City of Englewood, Ohio
I-70 Pump Station Replacement
2019

ADDENDUM 3

May 16, 2019

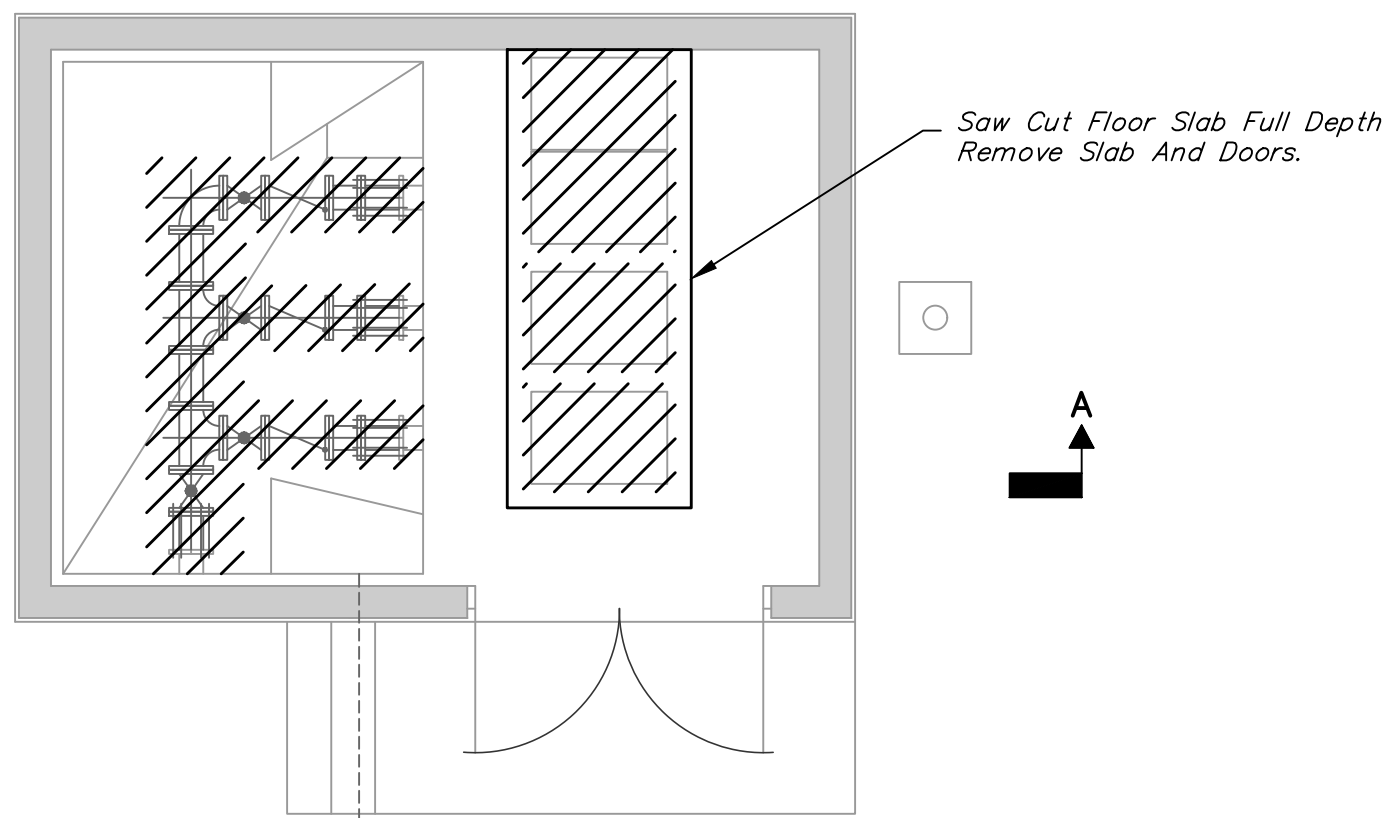
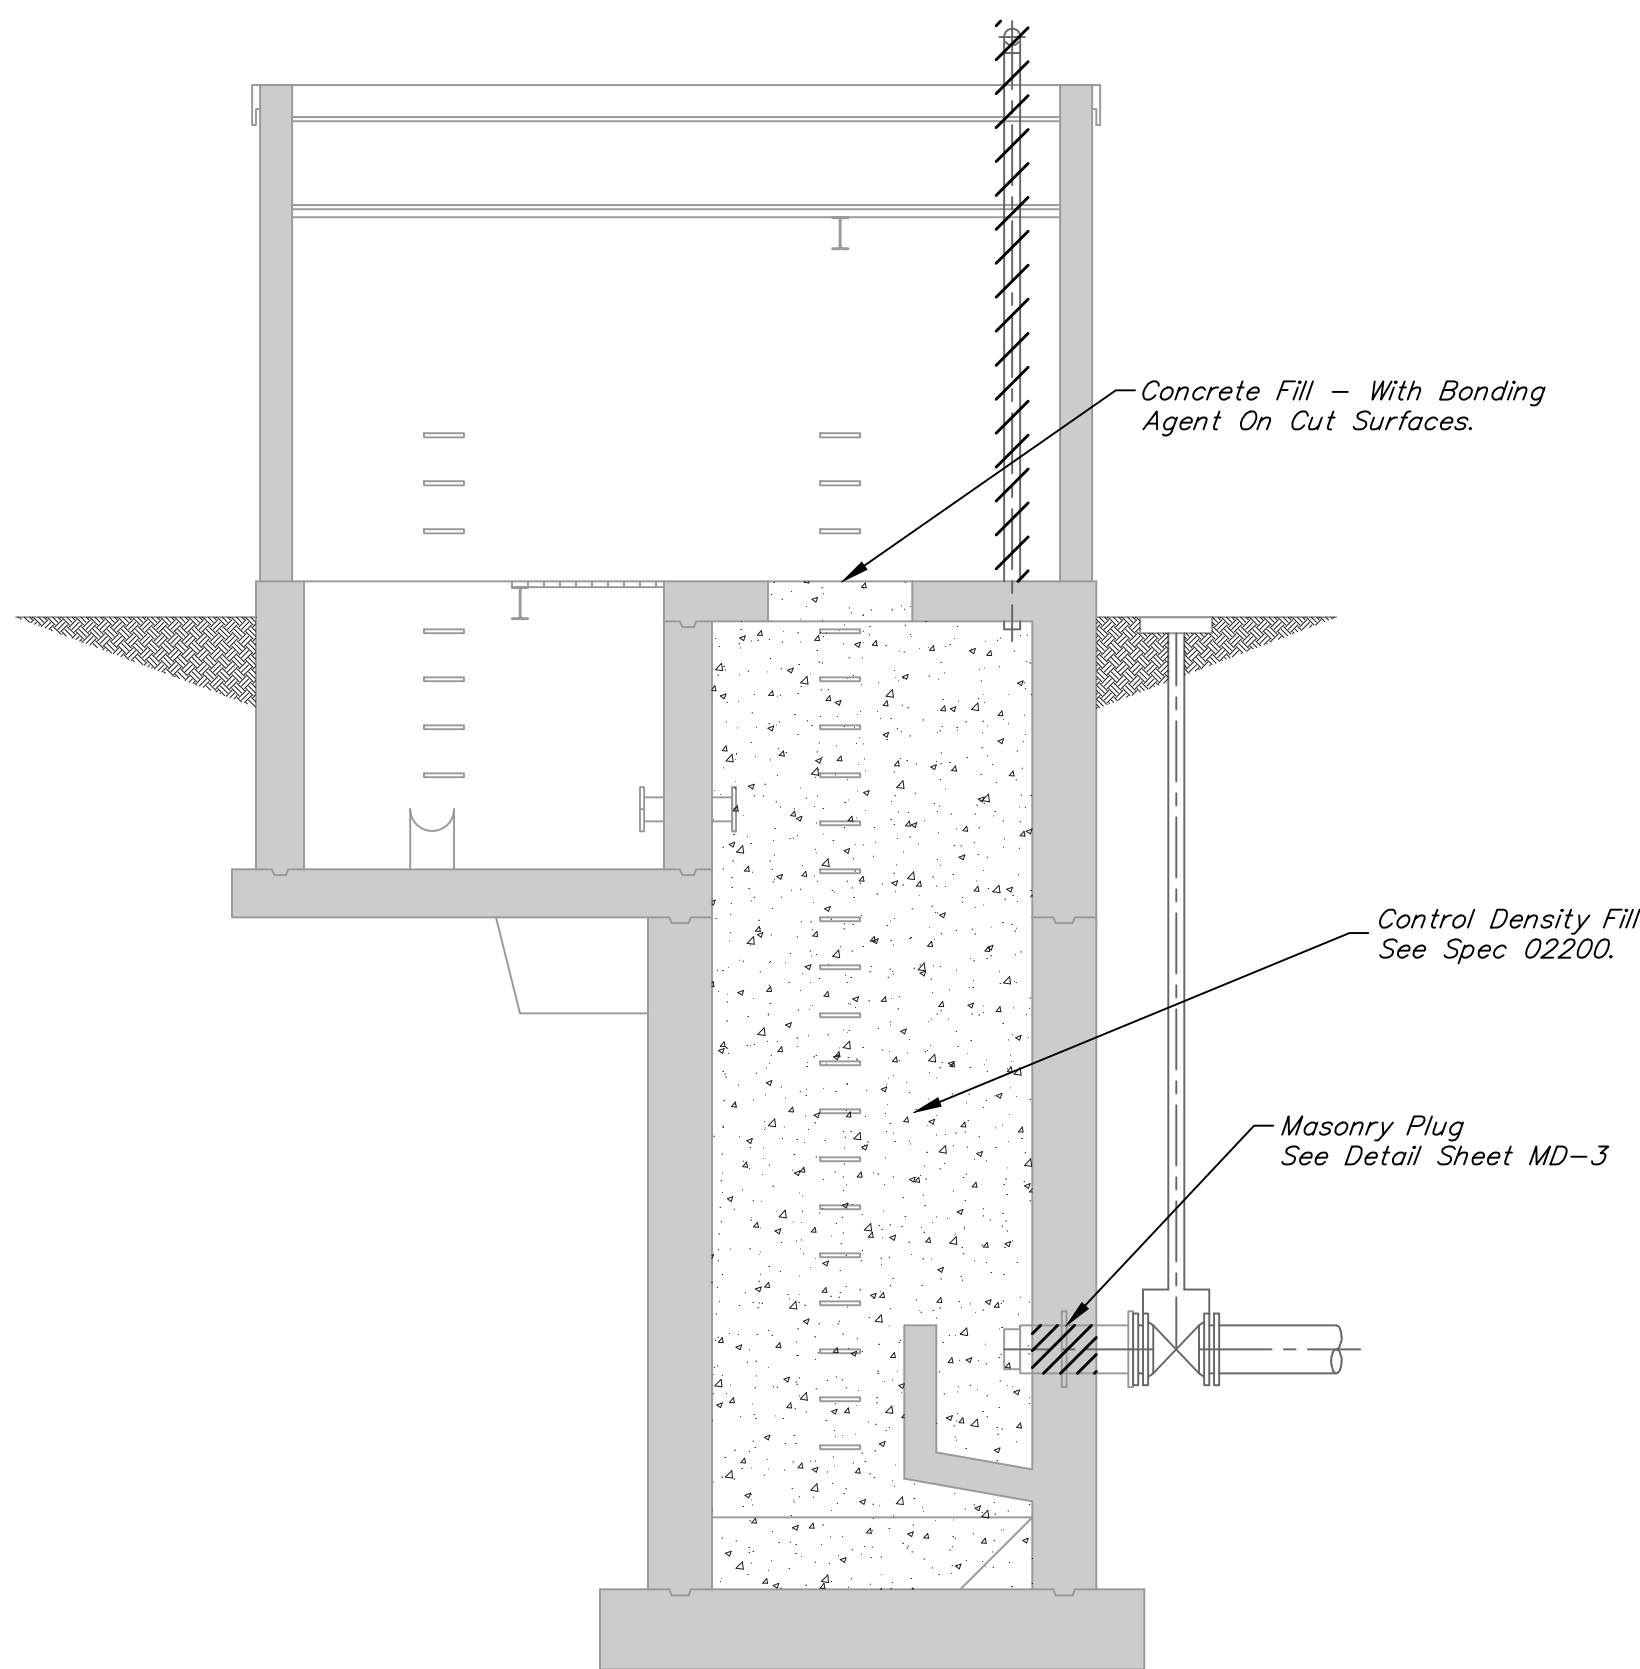
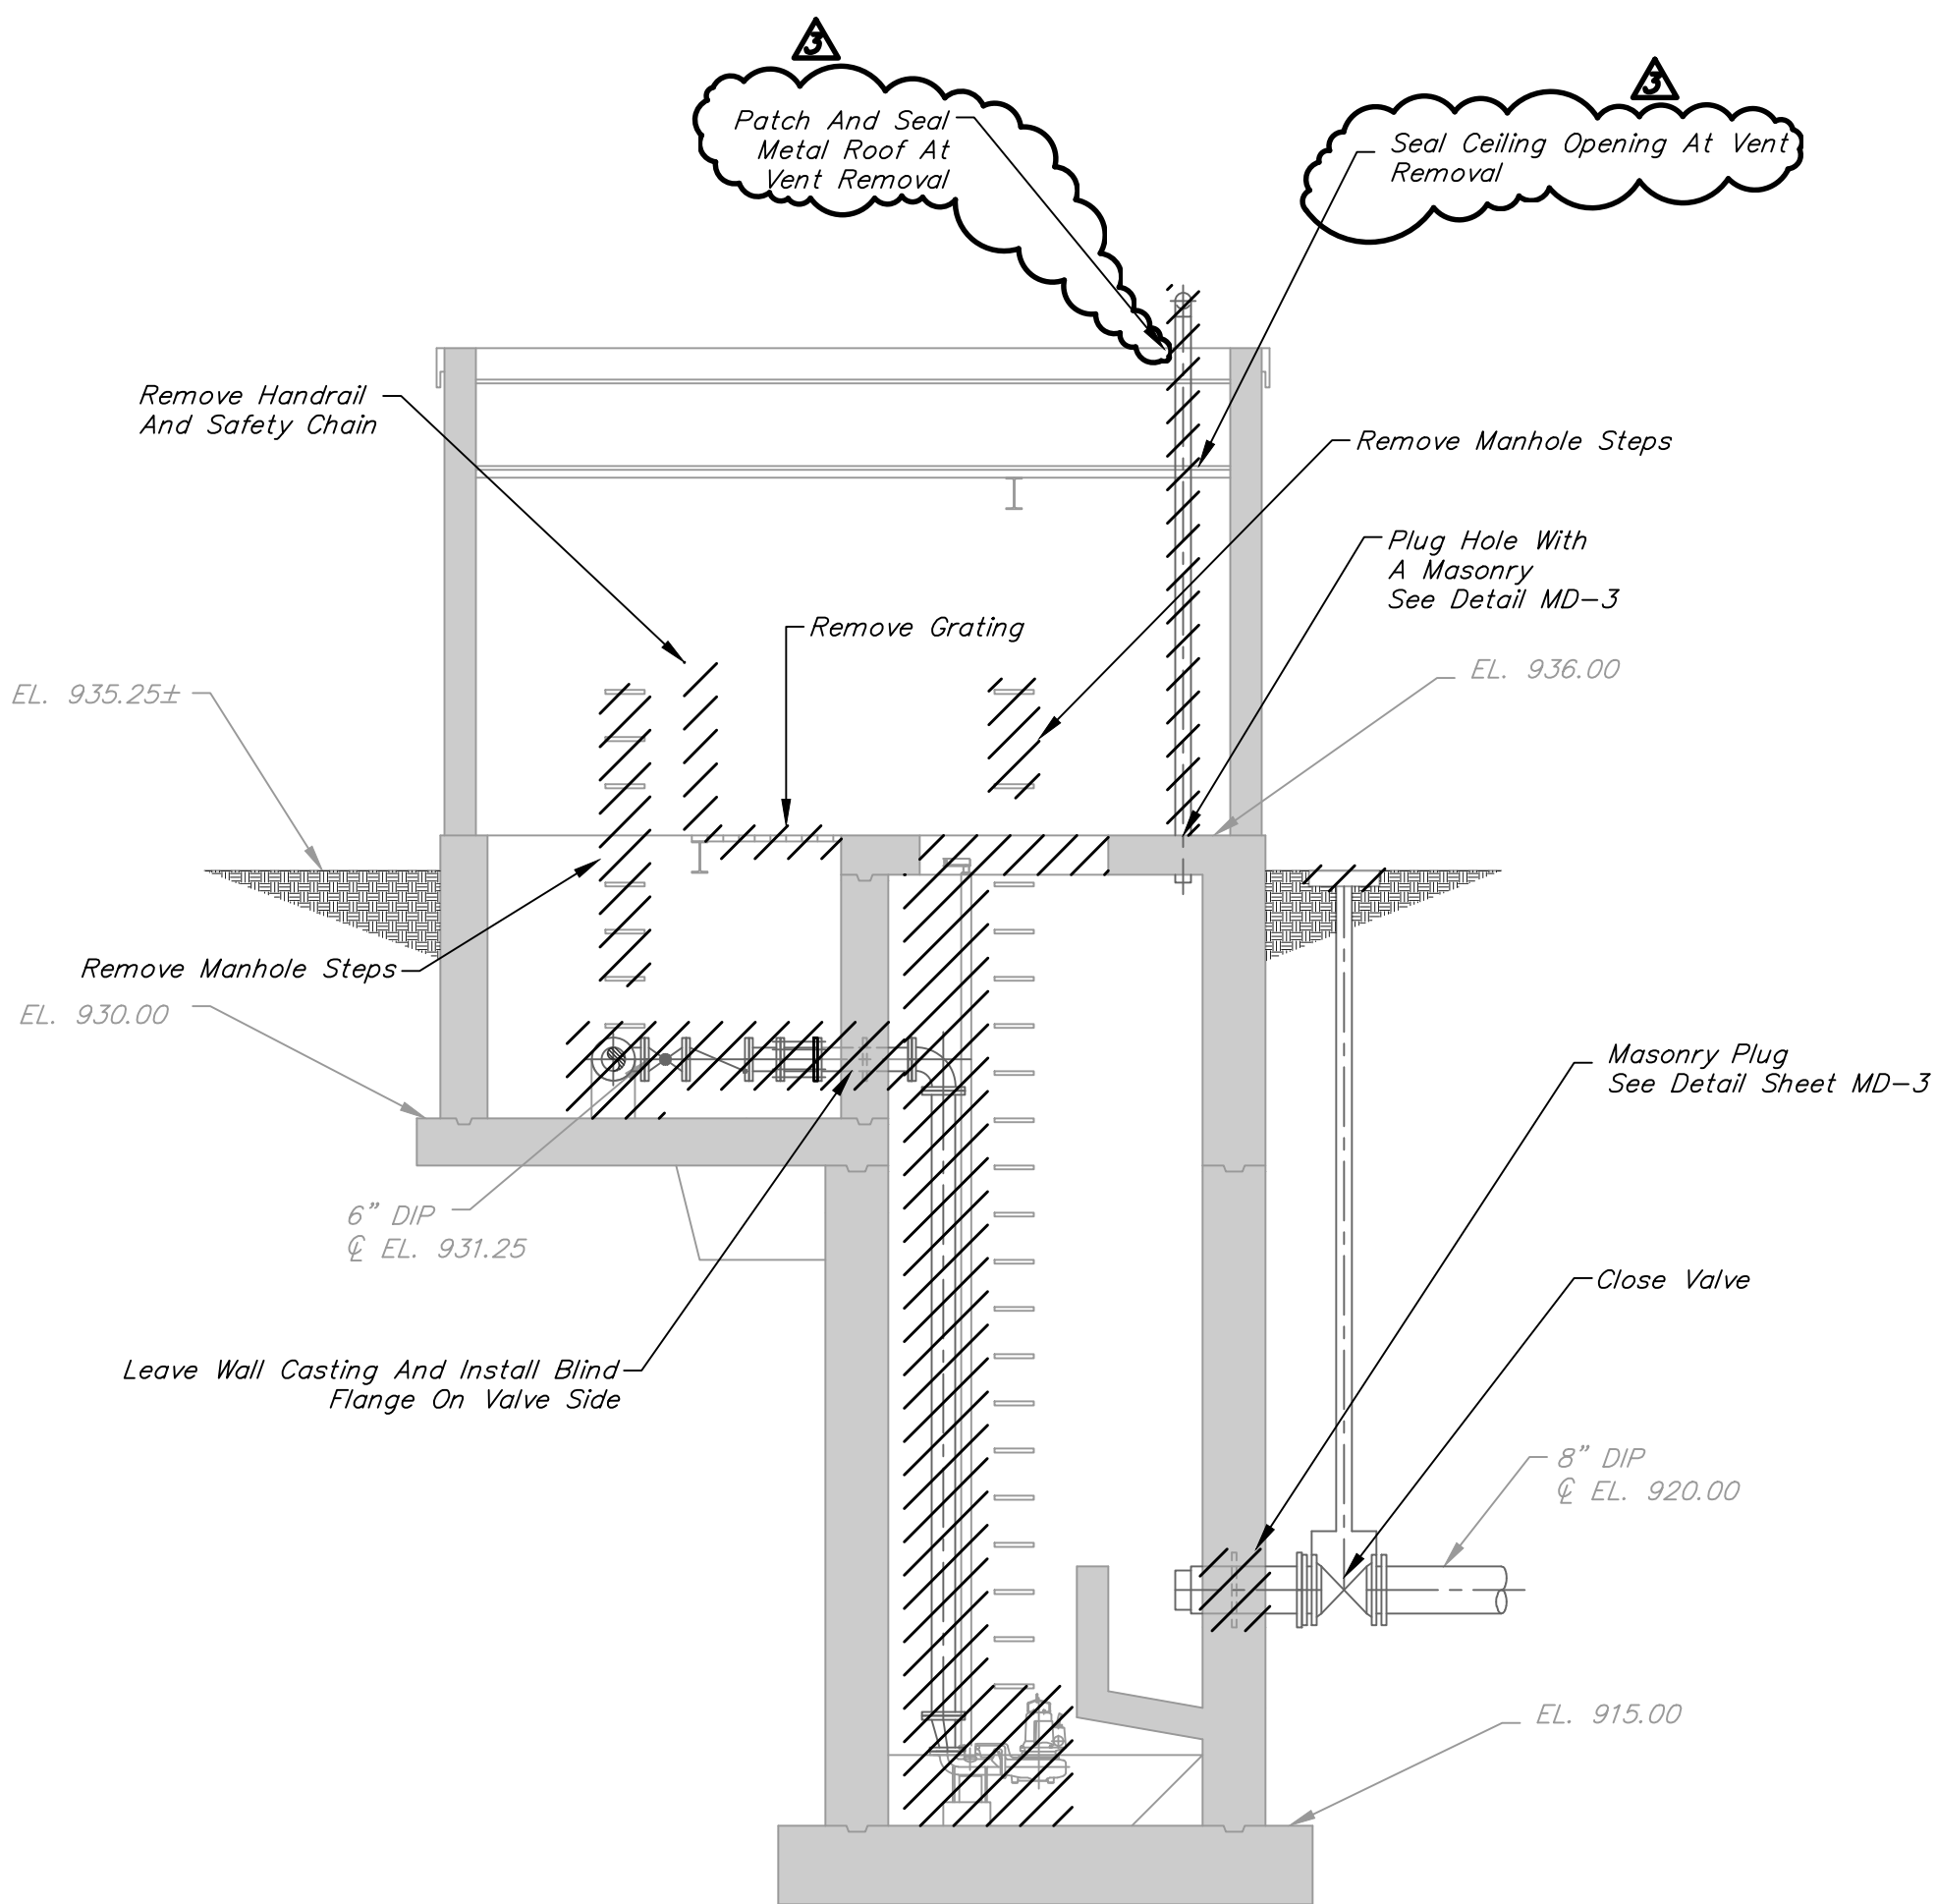
1. There does not appear to be any interior manhole coating called out in the paint schedule.
Manholes will not be coated. See Section C-02552, Par 4.01 for Xypex Additive to be used.
2. There is a vent pipe and an exhaust fan that penetrate the roof. Are they to be removed? Can Roof Patch detail be provided?

The existing exhaust fan will remain in use. See revised drawing R-1 issued as part of this addendum.
3. There is a louver that is shown to be removed from the existing building. Does this need to be filled with masonry?

The existing louver will remain in use and not removed. See revised drawing R-1 issued as part of this addendum.
4. Drawing E-3 calls out a power cable schedule under the notes in the one-line diagram. We cannot locate the schedule in the drawing.

Delete Sheet R-1, Existing Pump Station Removals- Plans and Sections, and Replace with : Revised Sheet R-1.
